American Telecommunications Certification Body Inc.
6731 Whittier Ave, McLean, VA 22101

RE: Palmone Inc.

FCC ID: O8FJIMI

After a review of the submitted information, I have a few comments on the above referenced Application.

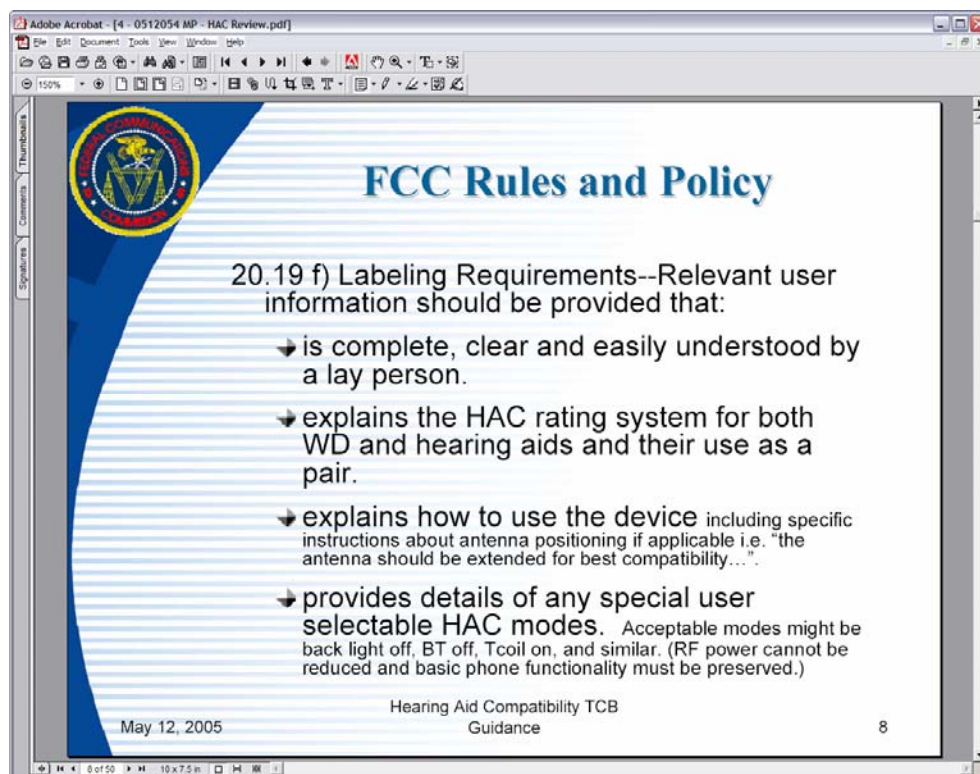
- 1) What kind of users information is provided to the user regarding HAC (i.e. manual, insert, packaging material, etc.) for compliance to 20.19(f). Please note the following from the FCC:

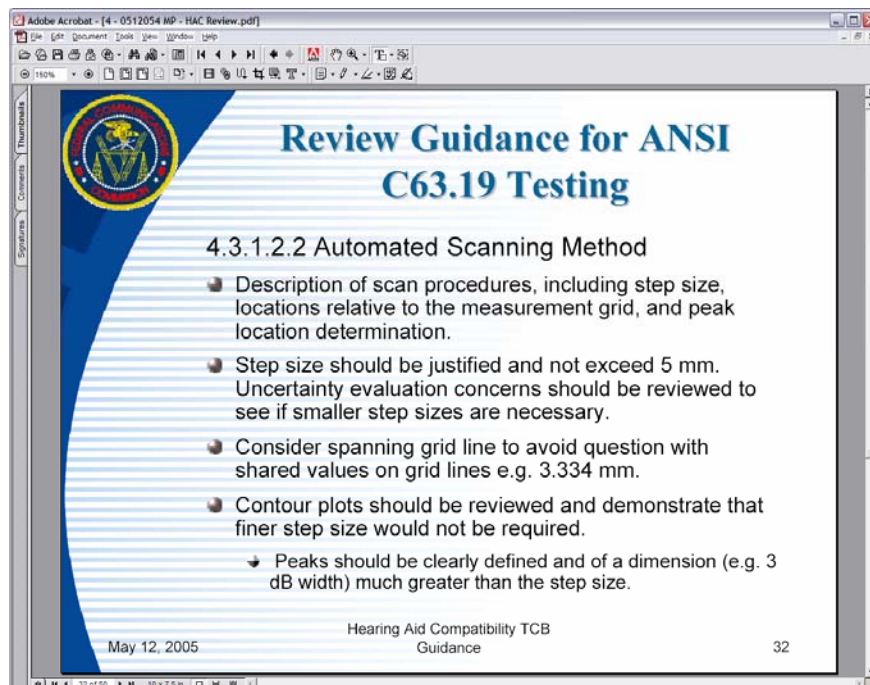
- 2) The test report cover and other portions of the report mentions C63.19-2005 but the engineering summary suggests this was tested under C63.19 – 2001 (page 4) instead. Please note that TCB's must carefully consult with the FCC for any reports granted using the C63.19-2001 version which would delay evaluation of this application. Please explain which version was used for testing. If relevant, please correct.
- 3) The test report references this as a prototype. The FCC asks for any differences between a prototype and the final production unit to be explained.
- 4) Test report should cite compliance to 20.19 according to 2.1033(d) of the rules:
2.1033(d)

Applications for certification of equipment operating under part 20, that a manufacturer is seeking to certify as hearing aid compatible, as set forth in §20.19 of that part, shall include a statement indicating compliance with the test requirements of § 20.19 and indicating the appropriate U-rating for the equipment. The manufacturer of the equipment shall be responsible for maintaining the test results.

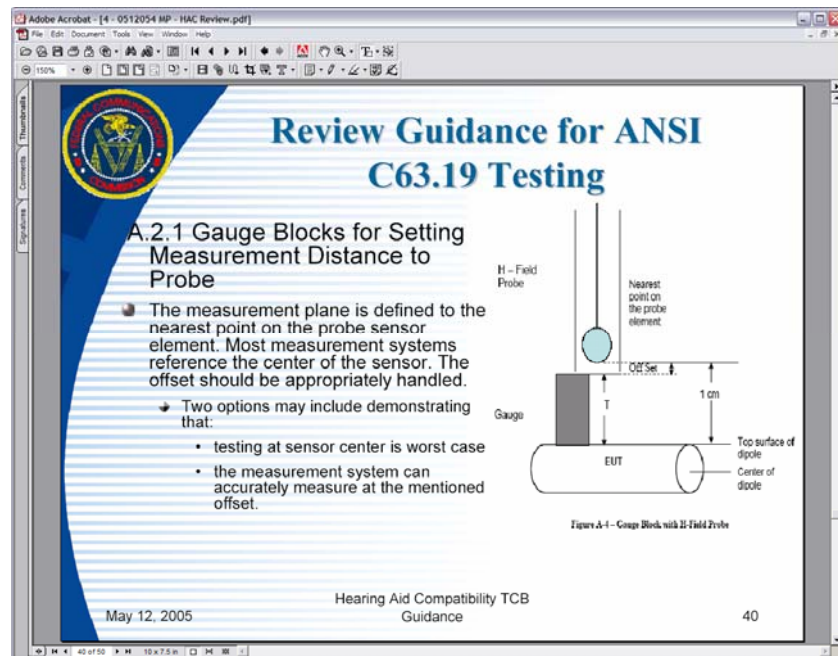
- 16) RF test procedures appear to be for clause 4, but the flow chart appears to be for Hearing aides. Please review/explain/correct as necessary.
- 17) Scan procedures do not support enough detail. For instance the procedures should clarify the information shown in the slide below from FCC training. Additionally, the contours on many plots suggest that maybe a smaller step size should have been used. Please adjust the test report or comment on the items given in the follow slide:

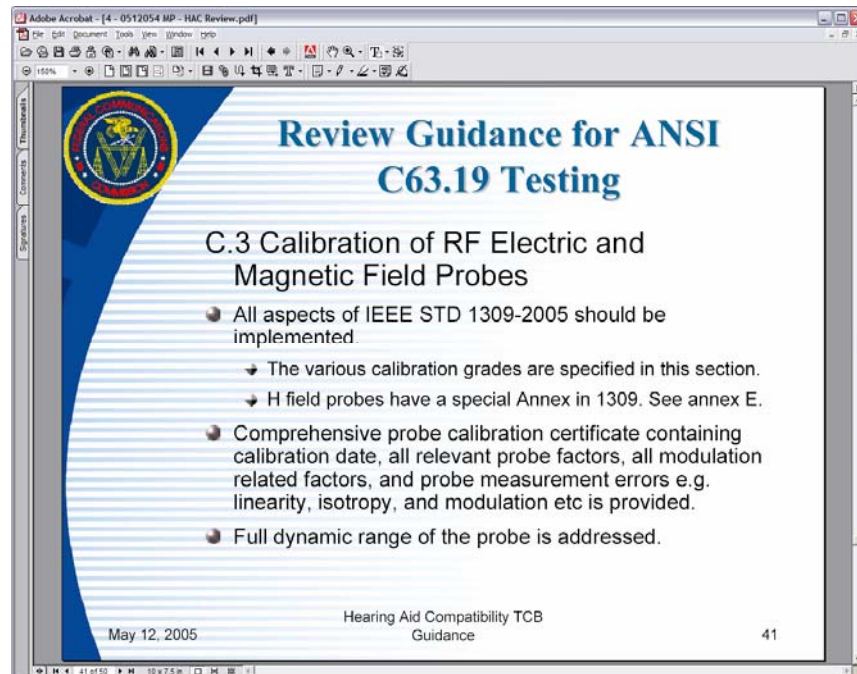
- 18) Please justify probe measurement at the center of the sensor. C63.19 recommends measurement at the nearest element point. Please include additional illustrations of the probe/elements showing more detail of the probe tip area. This is for compliance of information shown in the following slide:
